Project	<b>IEEE 802.16 Broadband Wireless Access Working Group</b> < <a href="http://ieee802.org/16">http://ieee802.org/16</a> >	
Title	<b>MIMO transmission for UL FAST_FEEDBACK and Fast MIMO Feedback Channels</b>	
Date Submitted	<b>2005-01-24</b>	
Source:	Wen Tong, Peiying Zhu, Ming Jia, Jianglei Ma , Dongsheng Yu, Mo-Han Fong, Hang Zhang and Brian Johnson  Nortel Networks 3500 Carling Avenue Ottawa, ON. K2H 8E9 CANADA	Voice: (613)-763-1315 Fax: (613)-765-7723  <a href="mailto:wentong@nortelnetworks.com">wentong@nortelnetworks.com</a>
Re:	IEEE 802.16-REVe/D5a, BRC recirc	
Abstract	Enhance the UL feedback channels by space time coding <a href="#">The update is in green font</a>	
Purpose	To incorporate the changes here proposed into the 802.16e D5a draft.	
Notice	This document has been prepared to assist IEEE 802.16. It is offered as a basis for discussion and is not binding on the contributing individual(s) or organization(s). The material in this document is subject to change in form and content after further study. The contributor(s) reserve(s) the right to add, amend or withdraw material contained herein.

# MIMO Transmission for UL FAST\_FEEDBACK and Fast MIMO Feedback Channels

Figure WWW

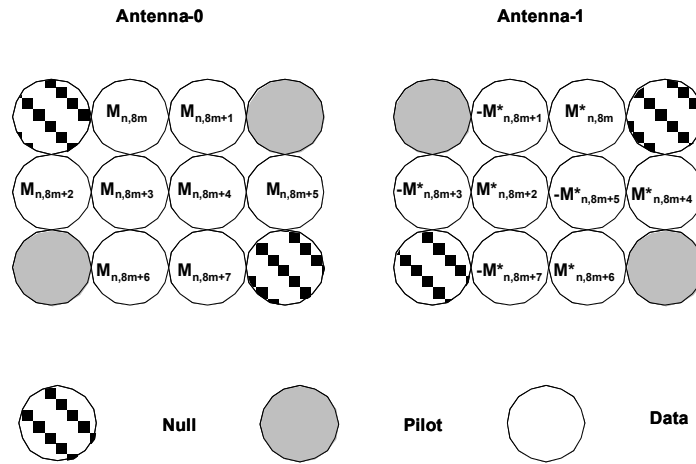
For UL MIMO-enabled MSSs (MSSs with two transmit antennas), STC may be applied in the transmissions of uplink feedback channels to improve the coverage. 2xM STTD is implemented (M is the number of receive antennas at BS). With the UL tile allocation shown in figure 249a for PUSC zone, the transmission from antenna-0 is the same as in non-MIMO operation, however, the different sub-carrier mapping method is applied to antenna-1 (see figure WW).

Figure XXX

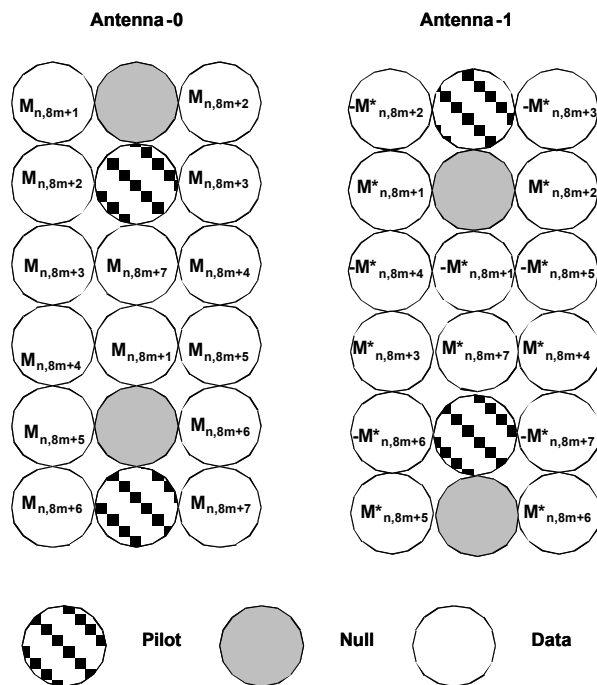
With the UL tile allocation shown in figure 252a for optional PUSC zone, two data sub-carriers should be punctured in each MIMO tile in order to obtain two extra pilot sub-carriers (same requirement for UL MIMO traffic channel). ~~To reduce the impact from the puncturing,~~ the first QPSK symbol (P0) in each orthogonal modulation index is removed (Table 295 and 296c) (see figure XXX). The mini subchannelization scheme described in section 8.4.6.2.4 shall be used with  $M=2$ , type = 01. CQICH channel shall be allocated **simultaneously** for two MSS, each uses one of the mini subchannel as specified in CQICH\_Enhanced\_Alloc\_IE().

Figure YYY

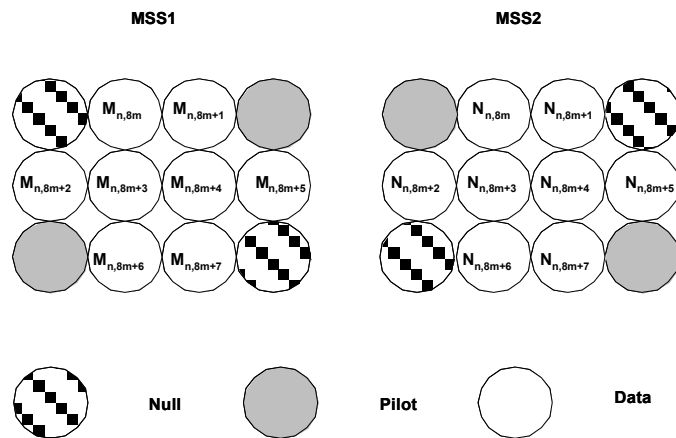
Multi-user collaborative spatial multiplexing can also be applied to uplink feedback channel to reduce the overhead introduced by the uplink feedback channels. In this case, BS assigns the same feedback channel resource to two single antenna MSSs. Each MSS selects the tile patten (pattern A or pattern B) according to the instruction from BS, and transmits the data burst independently with the same modulation and coding scheme for non-MIMO operation. Figure YYY and figure ZZZ show the mapping of the orthogonal modulation index for MSS-1 and MSS-2, where M is the orthogonal modulation index for MSS1 and N is the orthogonal modulation index for MSS2

Figure ZZZ

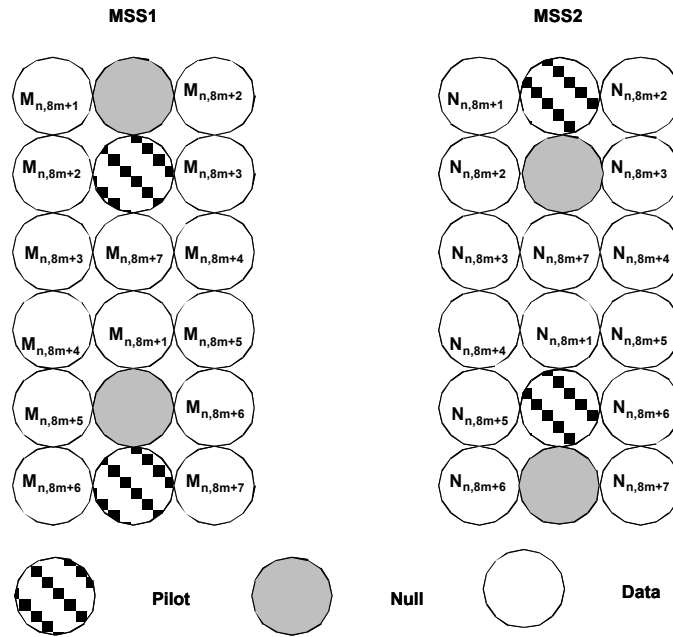
CQICH channel shall be allocated simulatanously for two MSSs, each uses one of the mini subcahnnel as specified in CQICH\_Enhanced\_Alloc\_IE(). The same physical CQICH channel resource can be allocated to another two MSSs through spatial multiplexing. The MSS shall use the pilot pattern as specified in CQICH\_Enhanced\_Alloc\_IE().
